Office Action Summary	Application No. 10/566,698	Applicant(s) BRANDT ET AL.	
	Examiner ANATOLY VORTMAN	Art Unit 2835

DETAILED ACTION

4. Claims 12-25 are rejected under 35 U.S.C. 103(a) as being unpatentable over US/2002/0112870 to Kobayashi et al (Kobayashi) in view of EP/0,854,666 to Lochbrunner et al. (Lochbrunner) (both references cited in IDS) and further in view of US/2001-0017766 to Murowaki et al (Murowaki).

FIG. 1

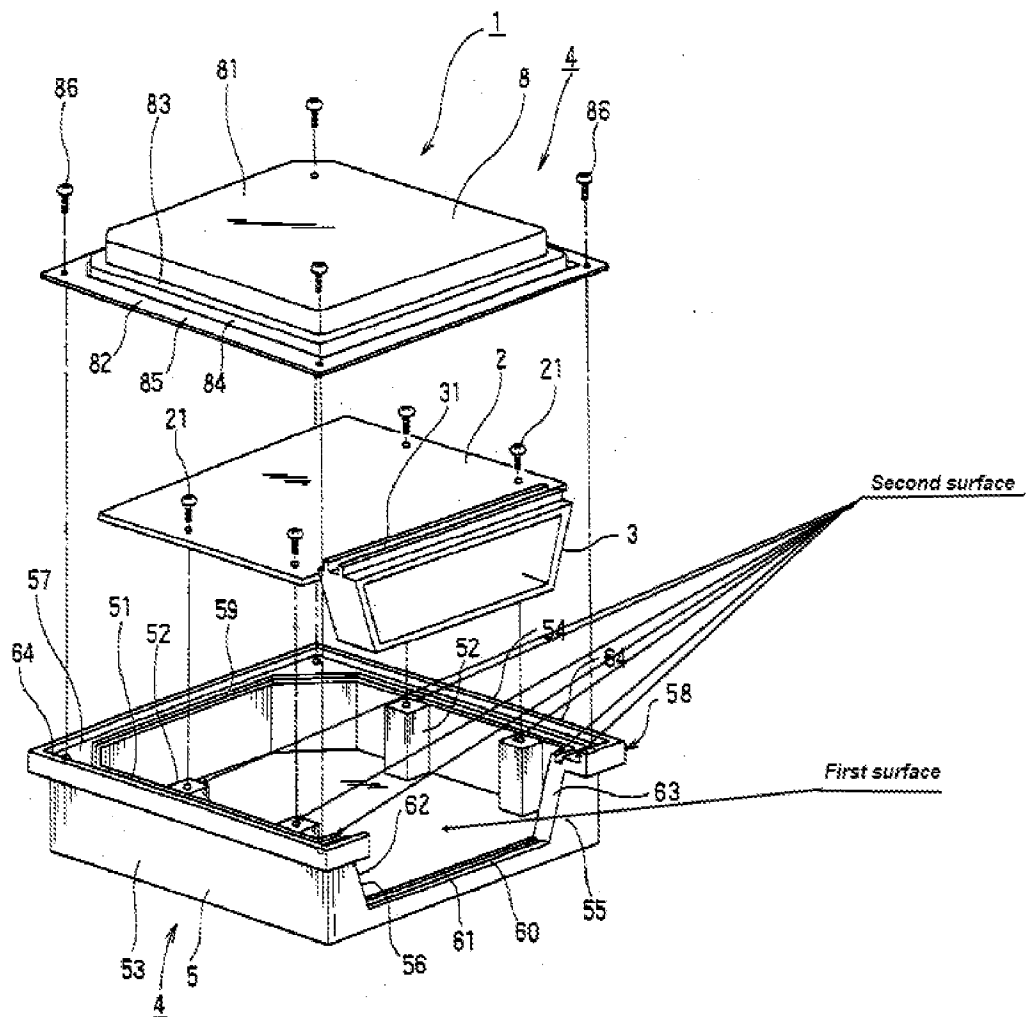
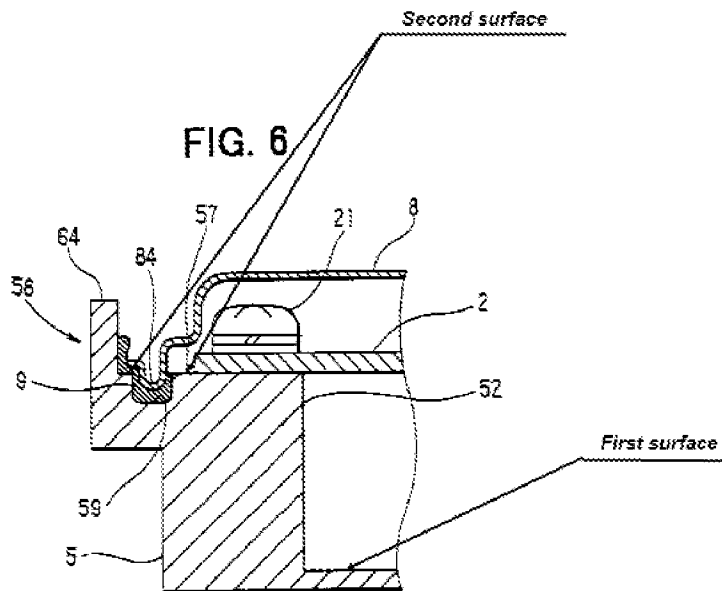
Regarding claims 12-14, and 21-25, Kobayashi disclosed (Fig. 1, 6) an electronic unit (control device for motor vehicle (see section [0003])), comprising: a printed circuit board (2) having a central region populated with electronic components (see section [0040]), and an edge region adjoining said central region (inherently); a housing (4) enclosing said printed circuit board, said housing having a housing floor (5) and a housing cover (8) connected to said housing floor, said housing floor, formed with a first surface having an outer region, a continuous wall surrounding said outer region of said first surface, and a raised second surface (57, 58) being raised with respect to said first surface and extending outwardly away from said continuous wall, said wall extending from said first surface to said raised second surface (see annotated Fig. 1 and 6 below); said central region of said printed circuit board being disposed spaced apart from said housing and said edge region being connected to said raised second surface (57) of said housing floor via a heat-conducting adhesive layer (9) (Fig. 4) (the adhesive inherently will

conduct heat); said housing cover having an edge formed with an annularly continuous projection (84) engaging into a corresponding groove (59) formed in said raised second surface (57, 58) of said housing floor (5), said projection and said groove together forming a groove-and-projection connection and being glued to one another, wherein said raised second surface of the housing floor dissipate heat away from said printed circuit board (2) (inherently) and serve as main support for said printed circuit board (2), but did not explicitly stated that the electronic components are disposed on both sides of the circuit board and that the same heat conductive adhesive is used to mount the circuit board to the housing of the electronic unit.

Regarding claims 18-20, Kobayashi as modified by Lochbrunner disclosed that said edge region is a printed circuit board section running along a large part of an edge of said printed circuit board in an annularly continuous manner (see Fig. 1 of Kobayashi or Lochbrunner), wherein said edge region has first side at least partly populated with the electronic components (see Fig. 1 of Lochbrunner), and a second side connected with said heat-conducting adhesive layer (see Fig. 4 of Kobayashi).

5. The gist of the Applicant's arguments is that, allegedly, "The printed circuit board 2 of Kobayashi et al. is not connected or bonded to the flange portion 58 (second surface), but rather is screwed to the four support posts 52 as can be seen in Fig. 1. The configuration of Kobayashi et al. does not meet the limitations of claims 12 and 21 that have been copied above". This is not persuasive. As clearly shown in the annotated Fig. 6, the second surface (57, 58) includes both: the top surfaces (57) of the support posts (52) and the surface (58) of the flange portion. Thus,

contrary to the Applicant's position, the configuration of Kobayashi et al. meets the limitations of claims 12 and 21. Therefore, the rejection is hereby maintained.
